AIR - HPT/LPT ACC VALVE ACTUATOR - INTRODUCTION OF A NEW ROD END TO HPT/LPT ACC VALVE  
ACTUATOR - PARKER HANNIFIN SB 5860017-75-91, 5910479-75-92 - CATEGORY CODE 6 -  
MOD.ENG-75-0046

AIR	V2500 ENGINE - HPT/LPT ACC ACTUATOR	INCORPORATION OF NEW ROD END, P/N 5943051-101
-----	-------------------------------------	---

AIR	V2500 ENGINE - HPT/LPT ACC ACTUATOR	INCORPORATION OF NEW ROD END, P/N 5943051-101
-----	-------------------------------------	---

Family Tree - HPT/LPT ACC Valve Actuator Ref. Catalog Sequence No. 75-24-52 Fig. 01,  
Item 100 (Part Number 5860017)  
Fig.1 (Sheet 1 of 2)

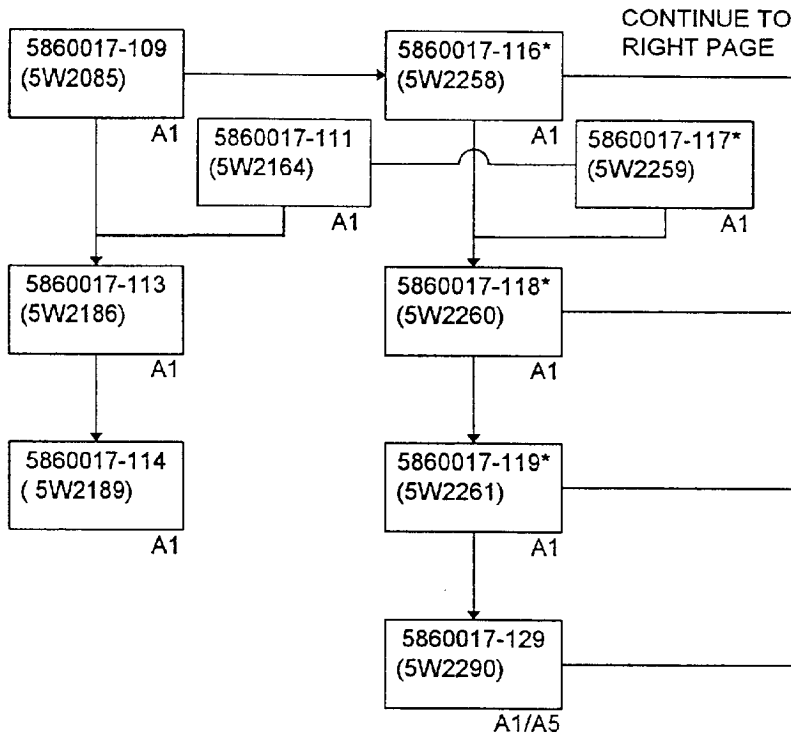
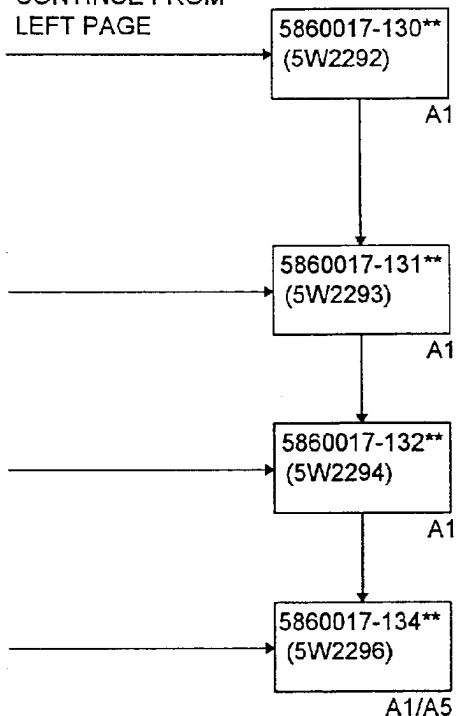
SB75-0046  
(PARKER 5860017-75-91  
AND 5910479-75-92)  
REPLACEMENT OF ROD END

OLD CONFIGURATION NO.	IAE PART NO.	NEW CONFIGURATION NO.	IAE PART NO.
5860017-116	5W2258	5860017-130	5W2292
5860017-118	5W2260	5860017-131	5W2293
5860017-119	5W2261	5860017-132	5W2294
5860017-124	5W2279	5860017-133	5W2295
5860017-129	5W2290	5860017-134	5W2296

Adjustment Aid Installation  
Figure 1

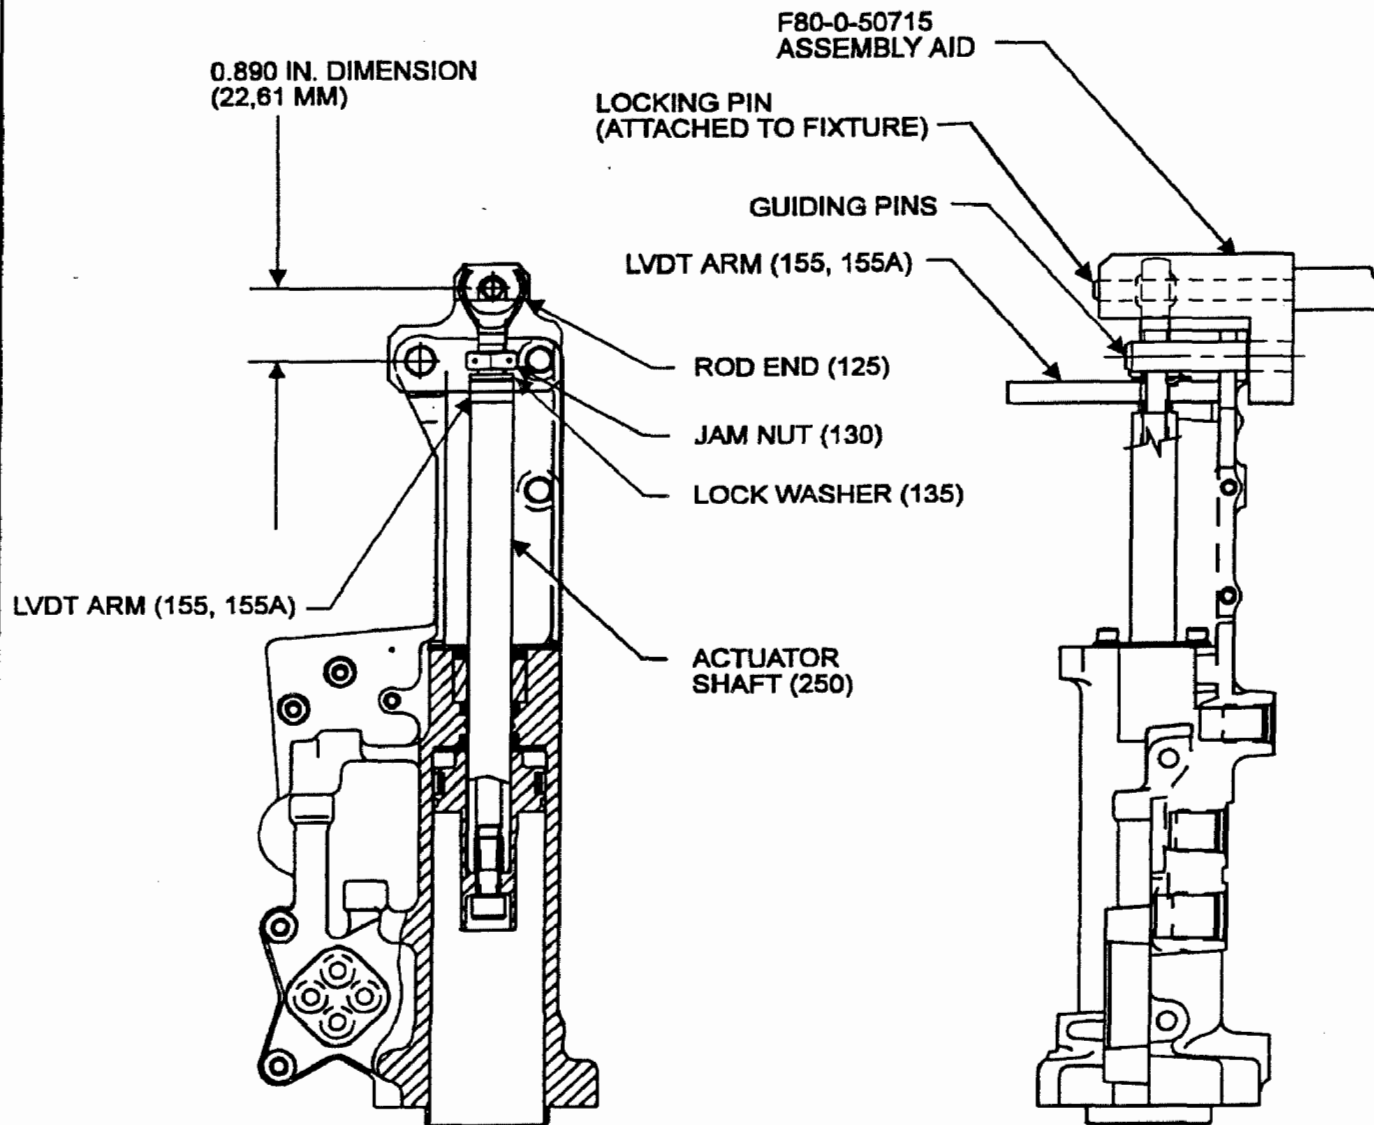
**CAUTION:** ADJUSTMENT AID, F80-0-50715, MUST BE USED TO ESTABLISH THE 0.890 INCH (22.61 MM) DIMENSION. THIS DIMENSION IS CRITICAL TO ROD END TRAVEL.

- (3) Install adjustment aid, F80-0-50715, onto actuator body assembly (360, 360A, 360B). Refer to Figure 1.

- (4) Install locking pin into rod end, 5943051-101. This adjustment establishes the 0.890 inch (22,61 mm) dimension.
- (5) Position tab washer (135) so that tab of washer aligns with slot in LVDT arm (155, 155A). Tighten jam nut (130) against tab washer. Remove adjustment aid, F80-0-50715.
- (6) Hold flats of actuator shaft (257, 257A) with special wrench, F80-0-50965, or equivalent, to prevent actuator shaft from turning. Use torque wrench, F80-4-50026, or equivalent, to run down and torque the jam nut (130) to 60 to 70 in-lb (6,8 to 7,9 N·m).

Adjustment Aid Installation  
Figure 1

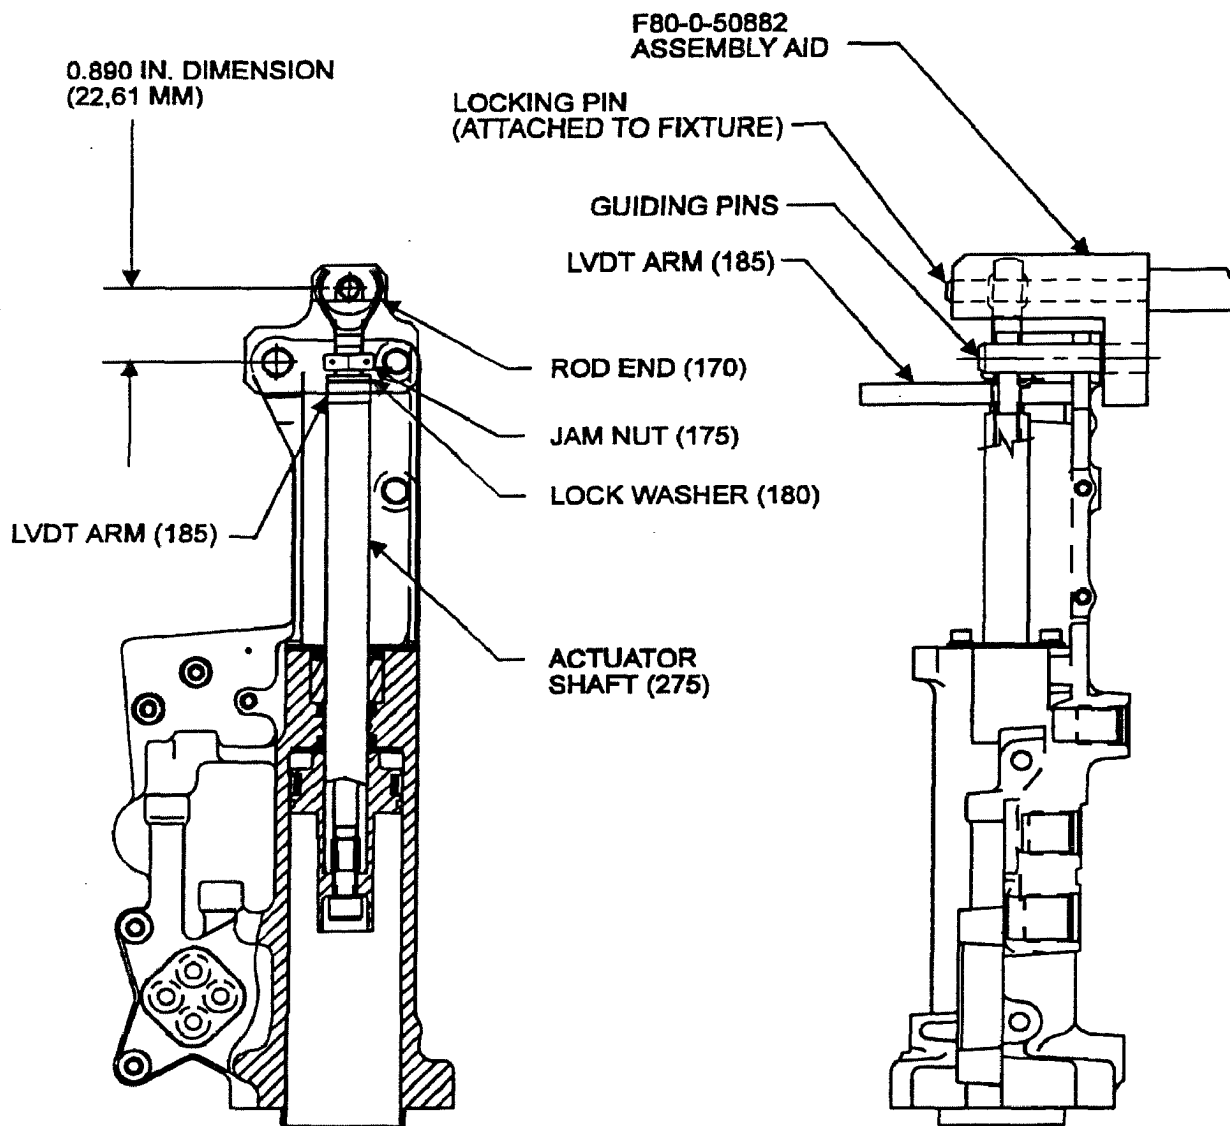
**CAUTION:** ADJUSTMENT AID, F80-0-50882, MUST BE USED TO ESTABLISH THE 0.890 INCH (22.61 MM) DIMENSION. THIS DIMENSION IS CRITICAL TO ROD END TRAVEL.

- (3) Install adjustment aid, F80-0-50882, onto actuator body assembly (365). Refer to Figure 1.

- (4) Install locking pin into rod end, 5943051-101. This adjustment establishes the 0.890 inch (22,61 mm) dimension.
- (5) Position tab washer (180) so that tab of washer aligns with slot in LVDT arm (185). Tighten jam nut (175) against tab washer. Remove adjustment aid, F80-0-50882.
- (6) Hold flats of actuator shaft (275) with special wrench, F80-0-50965, or equivalent, to prevent actuator shaft from turning. Use torque wrench, F80-4-50026, or equivalent, to run down and torque the jam nut (175) to 60 to 70 in-lb (6,8 to 7,9 N·m).
